Lead Local Flood Authority

RE: DM/26/0682 – Land At Hurst Farm, Hurstwood Lane, Haywards Heath, West Sussex

This is a Reserved Matters Application Pursuant to Outline Planning Permission Mid Sussex District Council (MSDC) Reference: DM/25/1630, Lewes District Council (LDC) Reference: LW/2510707 at Hurst Farm, for appearance, layout, scale and landscaping only.

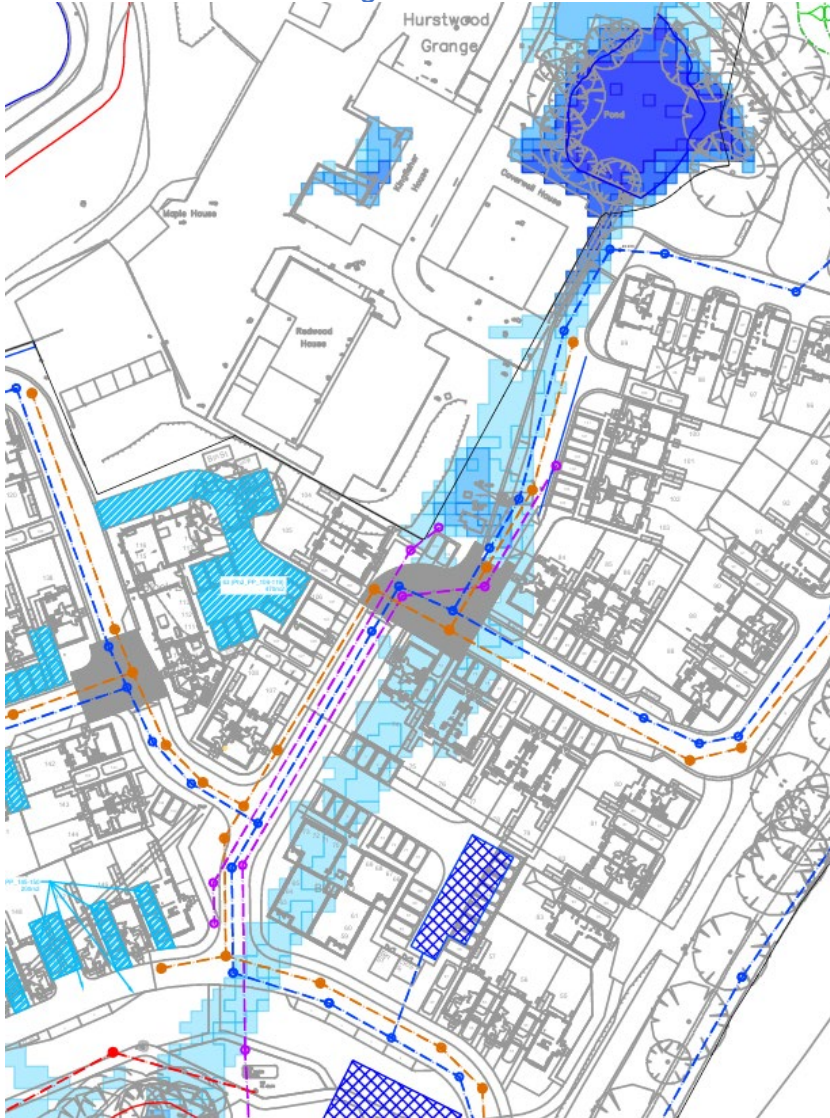
There are various locations where open features were proposed at outline stage, and have now been replaced with underground, traditional systems. The SuDS approach shall be used, by managing surface water where it falls, using source control SuDS features, rather than reliance on traditional underground systems formed of several tanks and oversized pipes. Examples of source control SuDS features includes rain gardens/bioretention areas, increased use of permeable paving, swales and filter drains.

This has not been adequately addressed. With the exception of permeable paving, there is very little use of source control SuDS features. This means that Standard 2 (Interception) of the National Standards for SuDS is not met. The comments in paragraph 2.20 are noted and understood.

Locally we require major applications to follow the [National standards for sustainable drainage systems \(SuDS\)](#), and would therefore strongly suggest using them when addressing our comments. The SuDS Manual offers guidance on designing SuDS for sites with different constraints, and the Ciria Enabling Development: Getting SuDS Right from the Start (C823F) document provides further information.

This is not adequately addressed. The application is not in accordance with the National Standards for SuDS, or the NPPF.
